STATE OF NORTH CAROLINA
DEPARTMENT OF TRANSPORTATION

Subject: Request for USACE 404 NW 14 Permit and NCDWQ Section 401 and Riparian Buffer Authorization Modifications for Widening of Airport Boulevard (SR 3015) from NC 54 to McCrimmon Parkway in Durham County. TIP No. U-3344A

The purpose of this letter is to request a modification to the U.S. Army Corps of Engineers (USACE) 404 Nationwide 14 permit and the North Carolina Department of Water Quality (NCDWQ) Section 401 and Buffer Authorization. There will be an increase of 2,320 ft² of buffer impacts in Zone 1, 2,367 ft² of buffer impacts in Zone 2, and 25 feet of stream impacts at Site 2. The revised permit drawings (Sheets 6, 6A and 8 of 8 for both the stream and buffers) are attached.

SHEET 6 OF 8

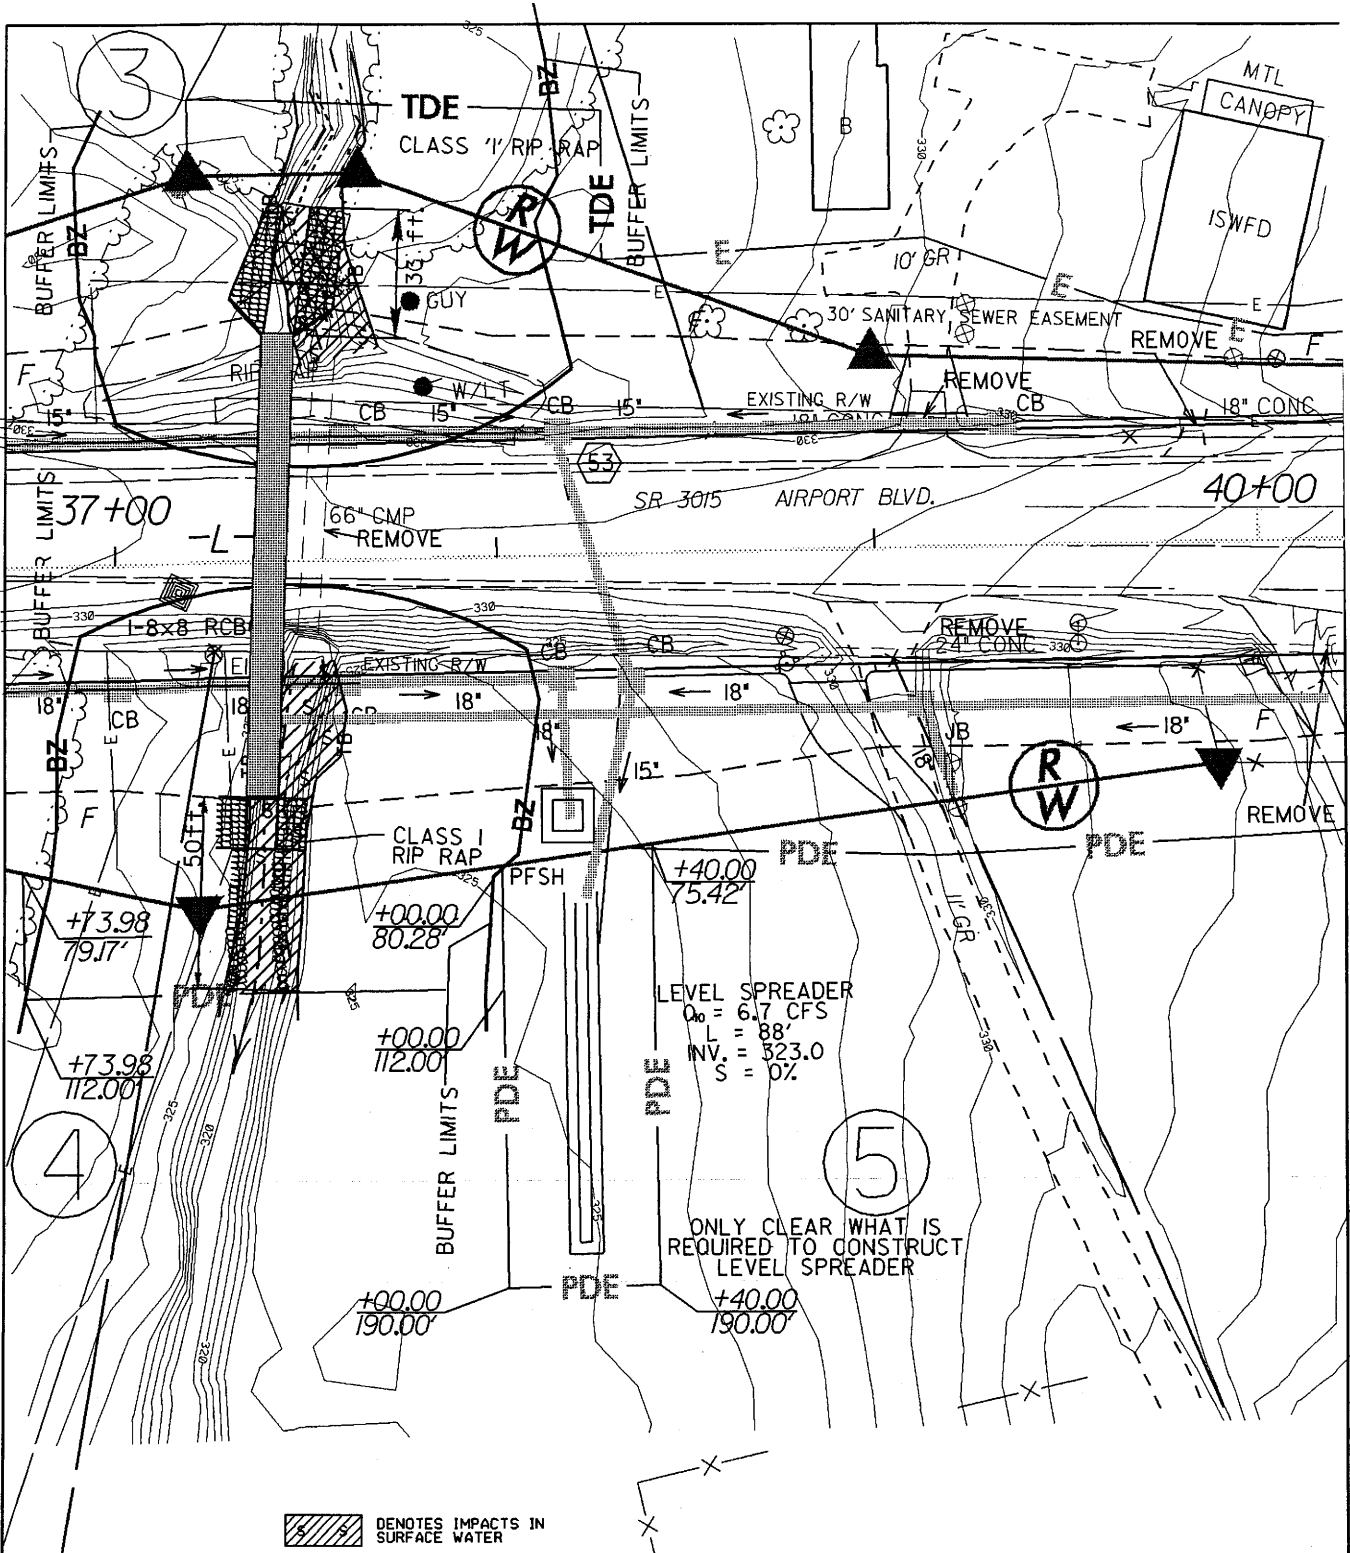
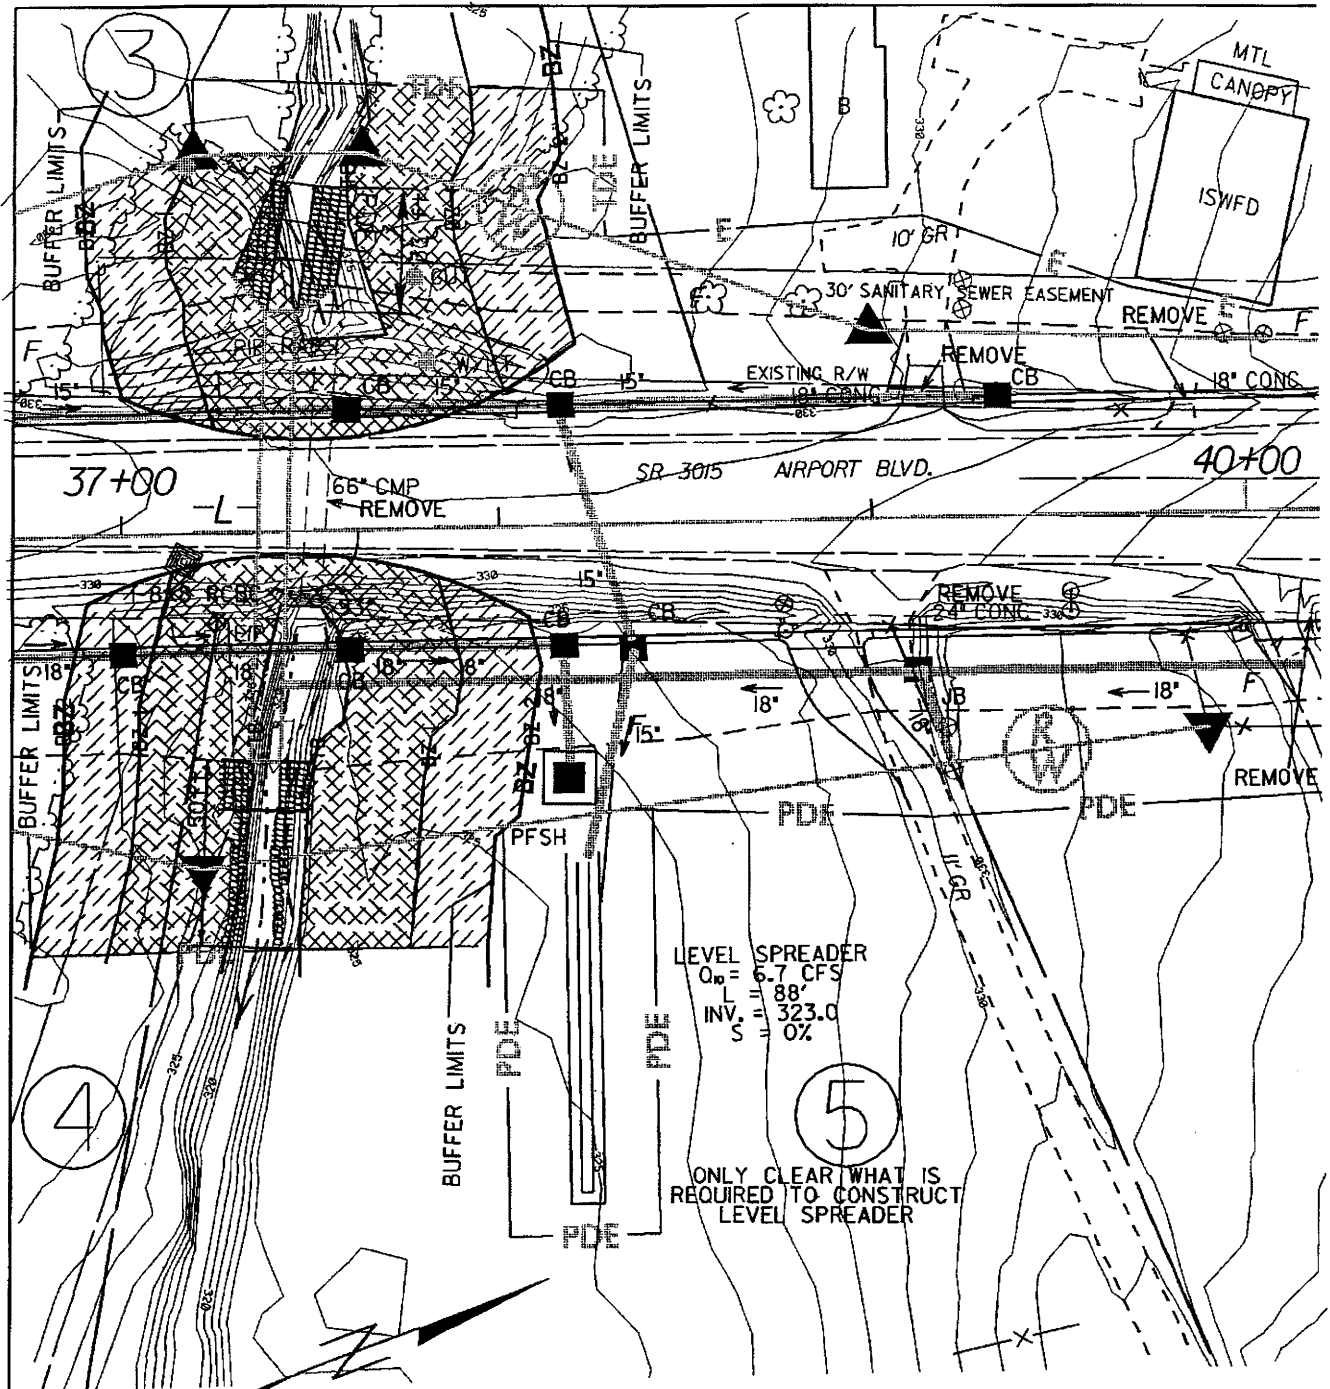
Background: The existing buffer certification is for 9,222 ft² of buffer impacts in Zone 1 and 4,921 ft² of buffer impacts at Site 2. Additional impacts of 4,687 ft² of buffers will be necessary to transition the culvert with the existing stream channel. The total buffer impacts will be 11,542 ft² in Zone 1 and 7,288 ft² in Zone 2 at Site 2. The existing NW 14 permit is for 109 feet of stream impact at Site 2. An additional 25 feet is needed for a total of 134 feet of impacts at Site 2 for the above stated reason.
